Greggs bakery | Twickenham  
PPA Meeting 1

## Proposed amendments

## Playspace and bridge connection

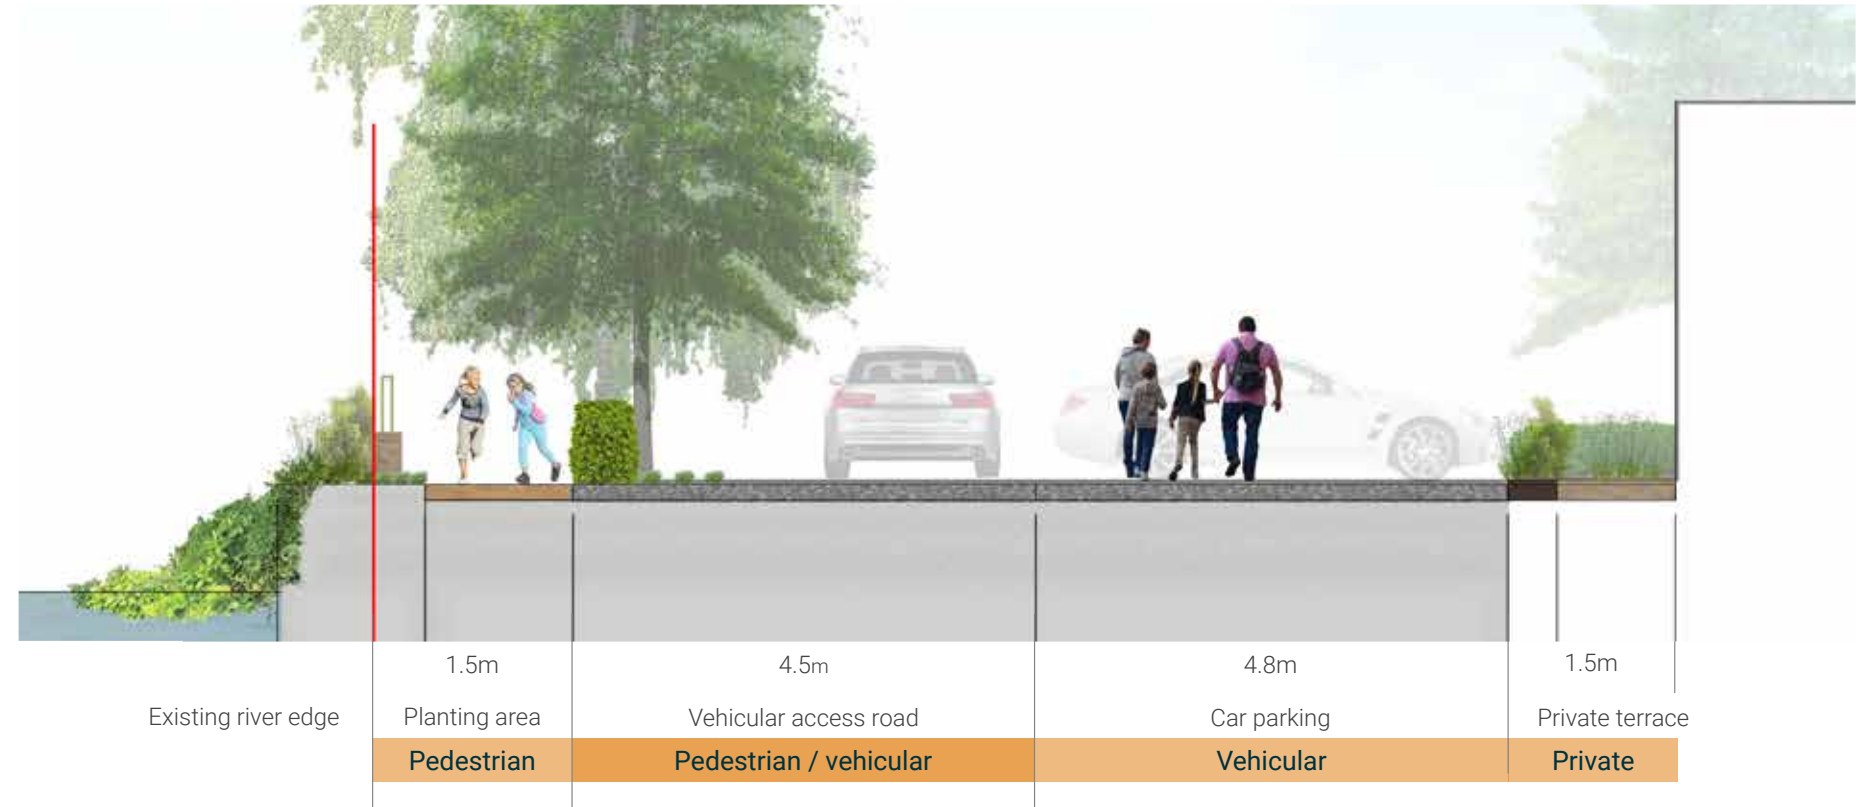
- Supportive of the clear public realm concept, however the location of car parking at the north end of the site and overall quantum could be reduced to improve the landscaping and river edge. Little space is left for seating, play and recreation. Consider mitigation measures to soften the hard edge towards the river-front and create a sense of place by the river edge.
- The space for the bridge landing feels compromised with car parking and play-space. Suggest taking forward the opportunity for a pedestrian crossing over the River Crane and the railway and interrogate this space to ensure sufficient landing area. Losing the four houses may help assist in improving this.

- Removal of 15 parking spaces to enhance the landscaping
- Greatly enhanced river edge treatment with extension of board walk and play space
- Detailed design of playspace and bridge landing
- Future-proofed bridge landing with additional safe guarded area to be added to planning submitted drawings

A safeguarded area facilitates the future bridge link without compromising the play area which can be seamlessly linked into the proposed boardwalk.

Amended illustrative section of the riverfront

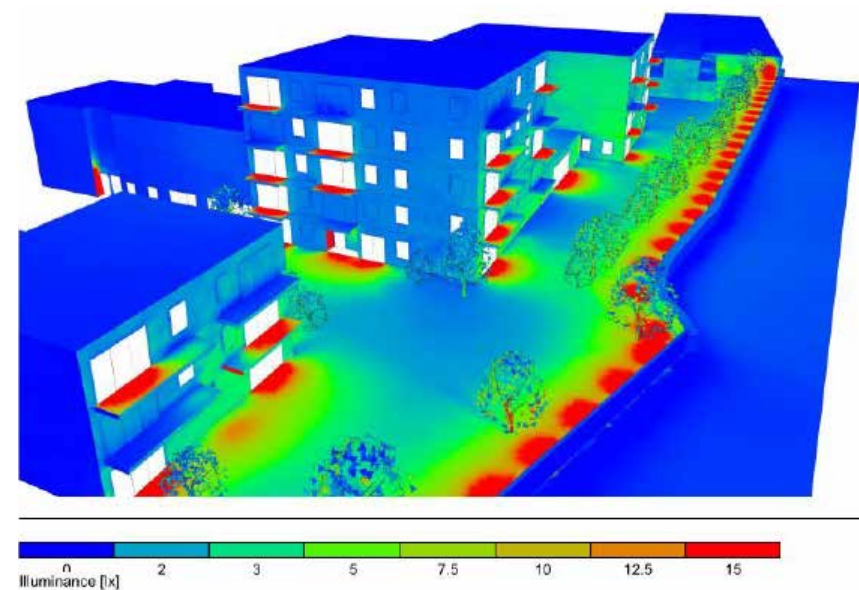
- A significant loss of riparian semi-natural habitat within 8m of the River Crane and contrary to policy LP15 of the Richmond upon Thames Local Plan.
- The lighting is encroaching on the river corridor and channel. Light spill could be better prevented through the use of a natural corridor as a screen for the river.
- No natural corridor to the River Crane, therefore increased risk of roadside runoff into the watercourse and the prevention of improving the Biological element status of the Water Framework Directive.

- Enhanced landscaping at river edge with additional tree planting, low level wall and planting designed to reduce light-spill and retain dark corridor
- External lighting analysis retested to verify this
- Parking and hard landscaping reduced to lower the risk of roadside runoff
- Overshadowing study undertaken showing a reduction in overshadowing through the year when compared to the existing condition

# Massing Improvements - Gould Road & Crane Road

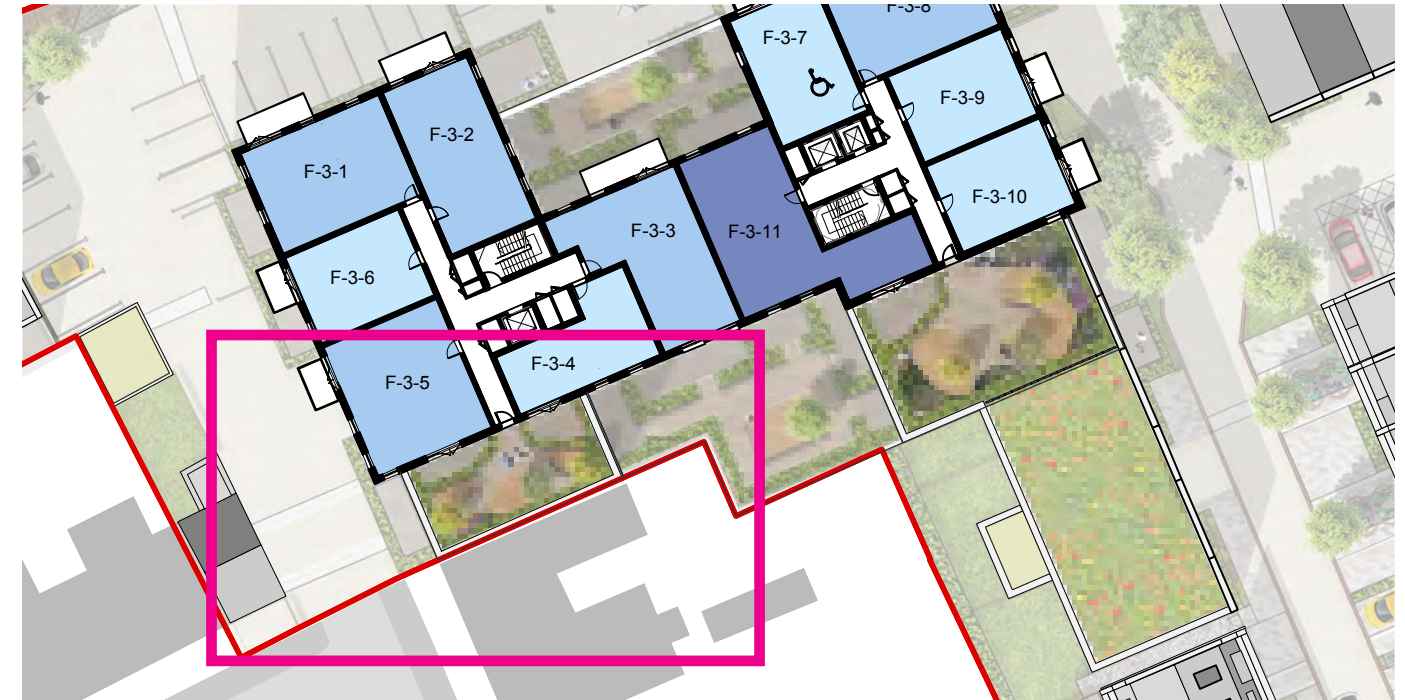
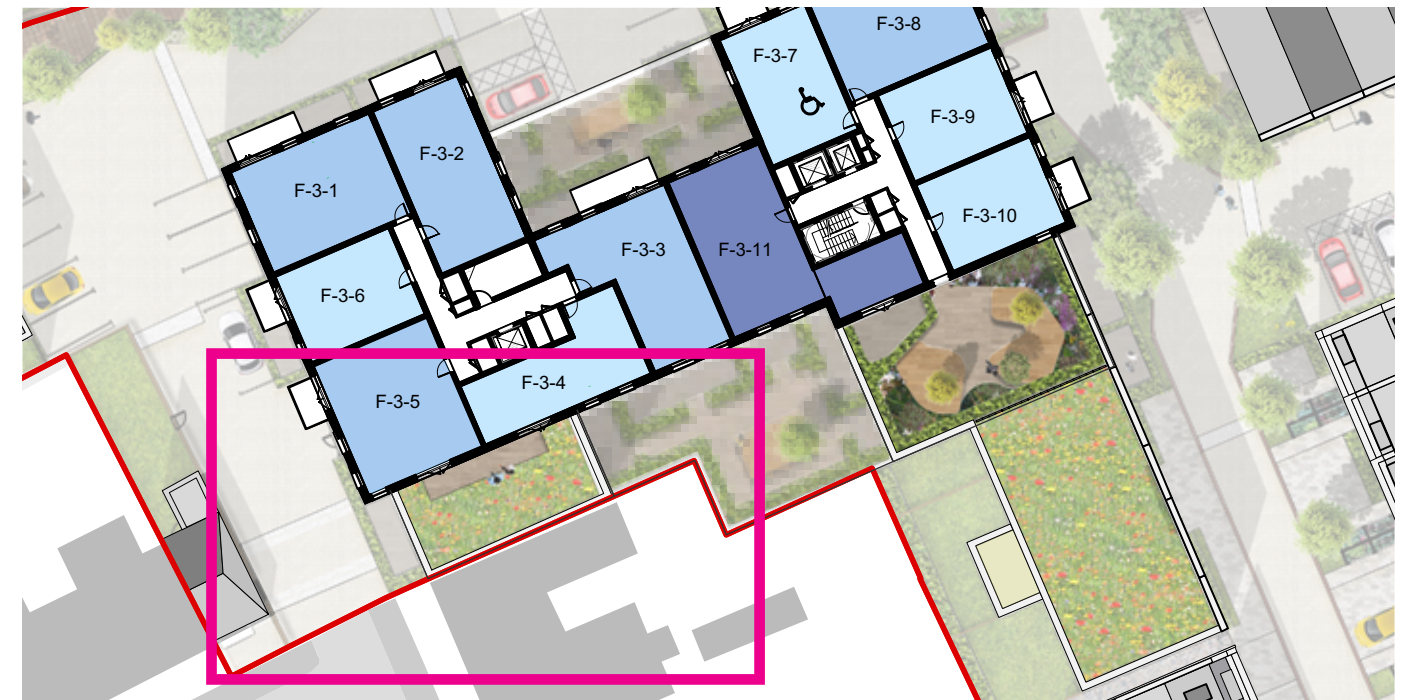
- Concerns over the massing at the junction of Gould Road and Crane Road in relation to existing terraces and overlooking from the roof gardens in Building F.
- Fourth Storey and balconies to the western end of Block F have a negative impact
- Review the lantern roof and look at the option of a flat roof instead. Also not convinced of the darker tone.

- Reduce parapet and roof terrace extent at junction of Gould Road and Crane Road
- Amend treatment of fourth floor and roof profile to reduce visual presence on the street
- Change material to reduce 'heavy' appearance
- Retain lantern profile and roof pitch to best respond to context
- Amend the design of balconies facing west towards Gould Road houses

## Comparison of Elevations

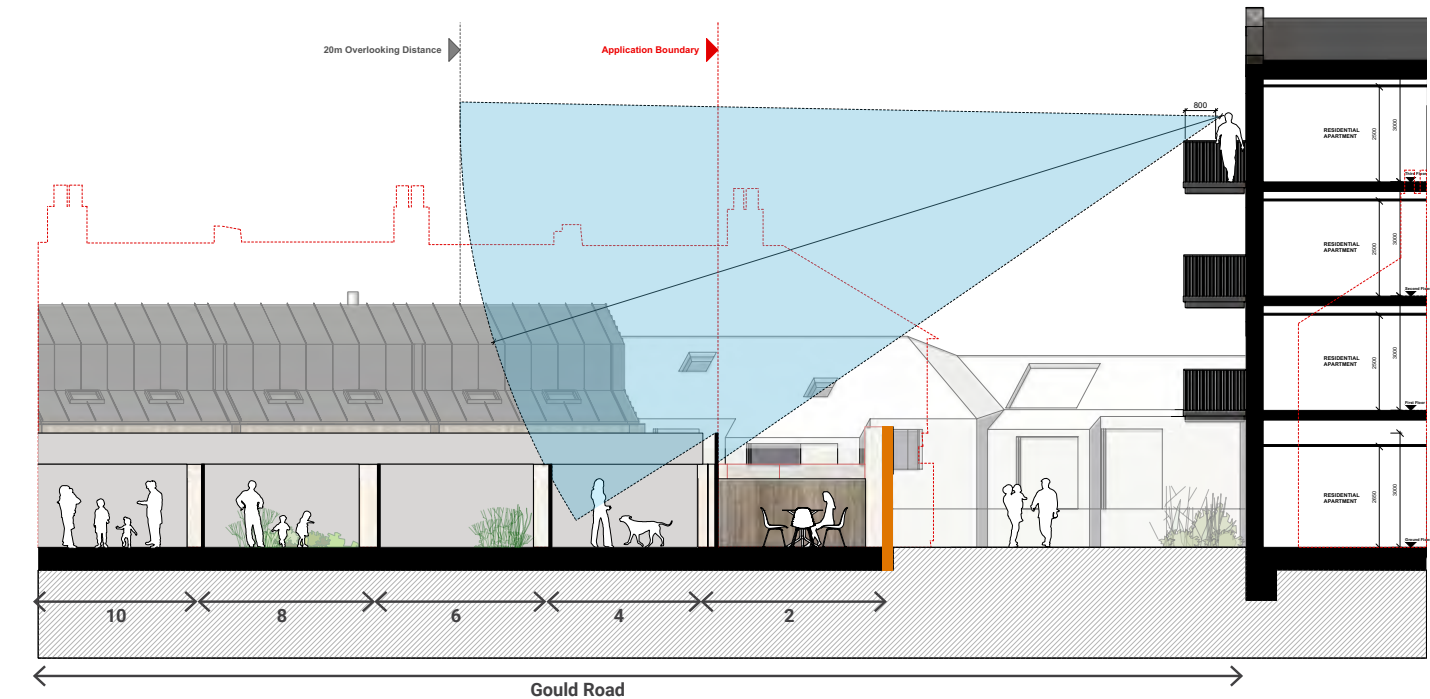
1. Change of top floor and roofscape
2. Balcony design amended
3. Massing reduced and communal roof terrace omitted

Top floor section through Apartment Block F

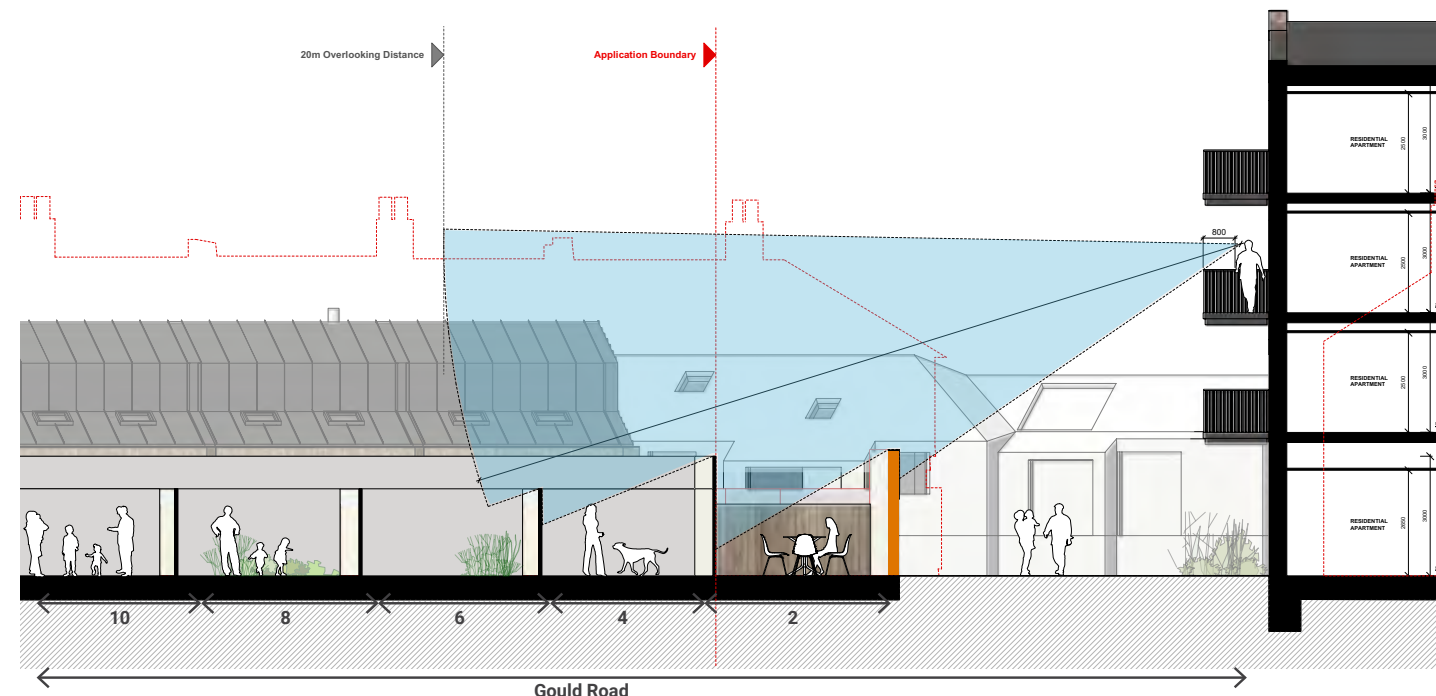
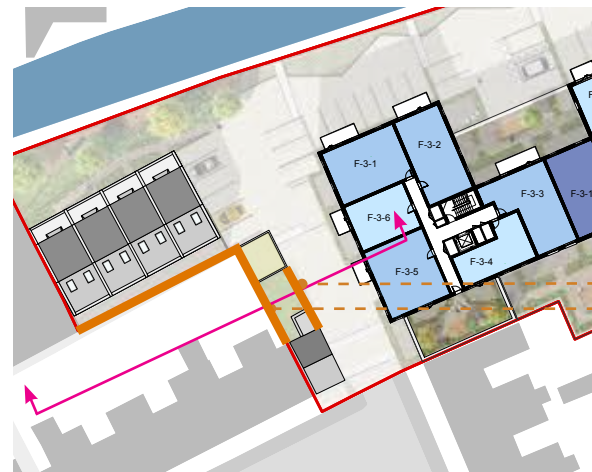
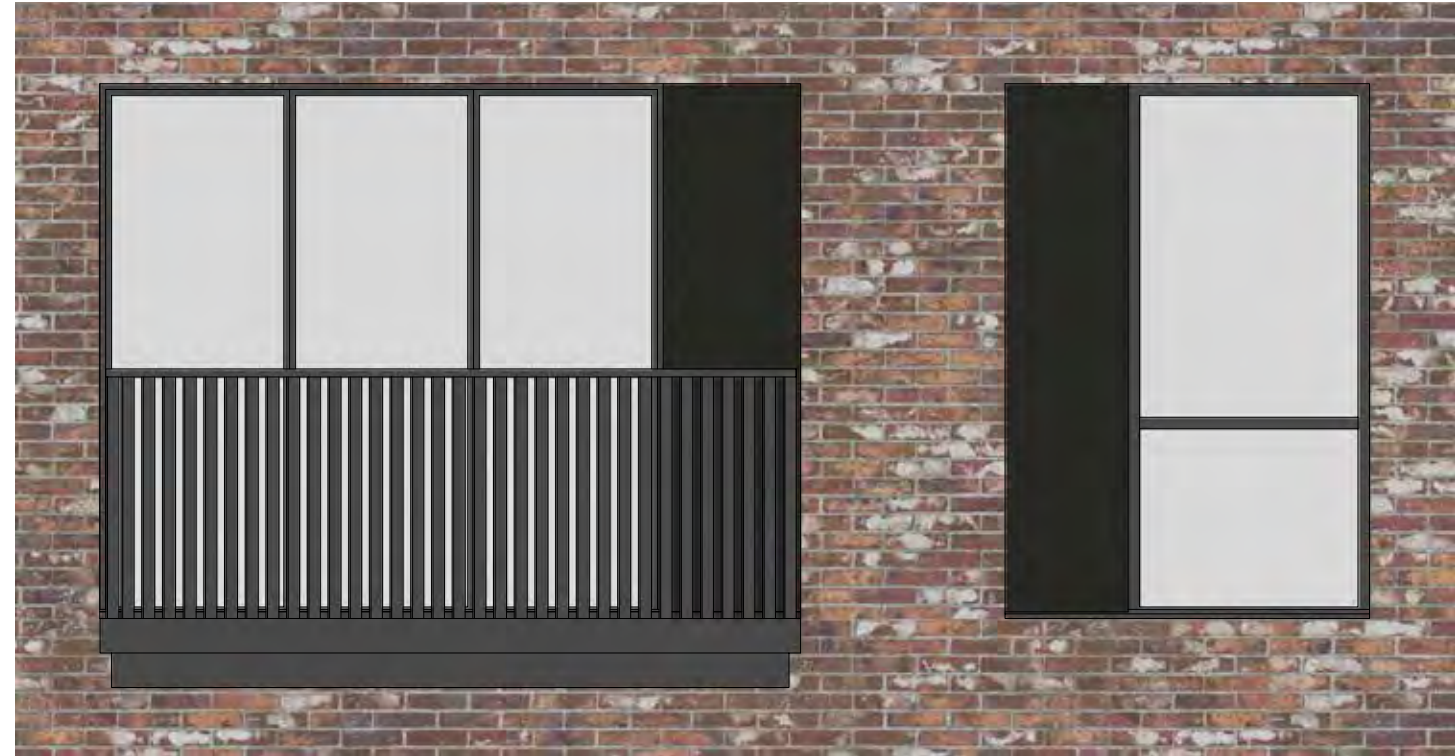
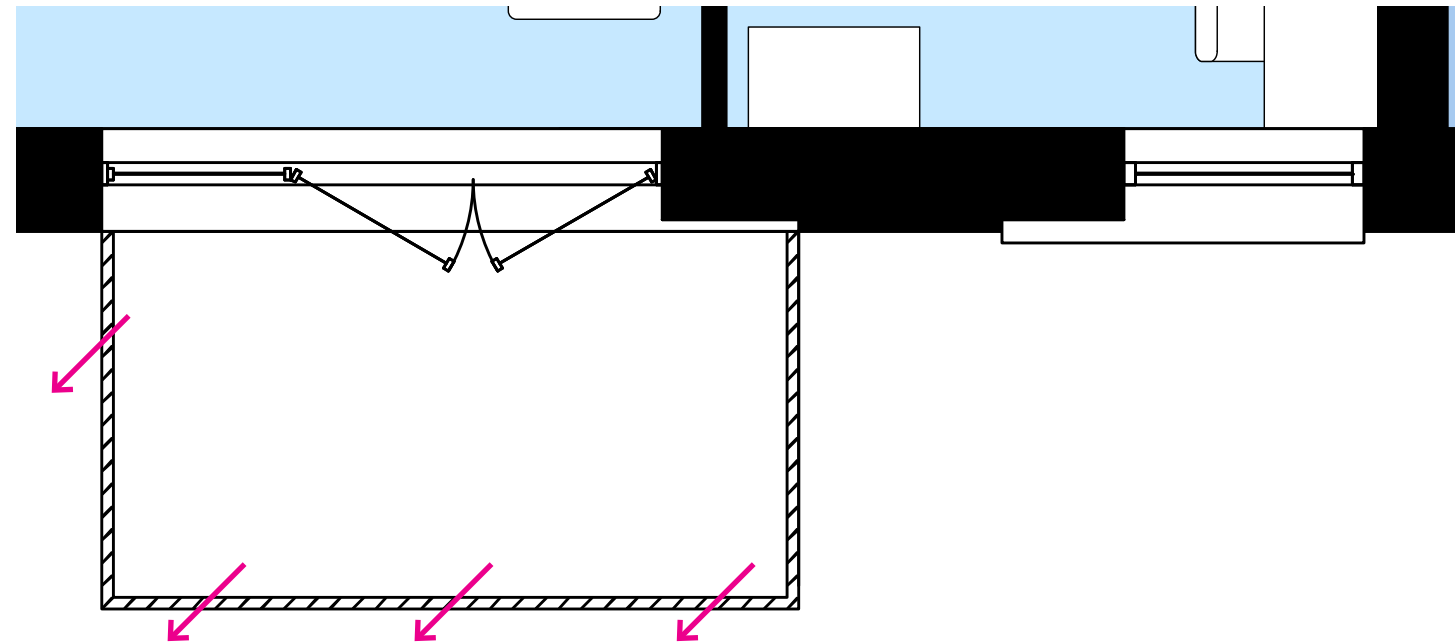
- Fourth Storey and balconies to the western end of Block F could have a negative impact and potential overlooking

- Overlooking to neighbouring gardens minimised by garden of number 2 Gould Road
- Overlooking from top-floor apartments further reduced by extending existing perimeter wall at site application boundary.
- Angle of balcony fins reduces low level incidental views to neighbouring properties when sitting

Boundary wall to be retained to the rear of Gardens of Gould Road

Balcony railings amended to blades directing views towards the river providing residents with additional privacy
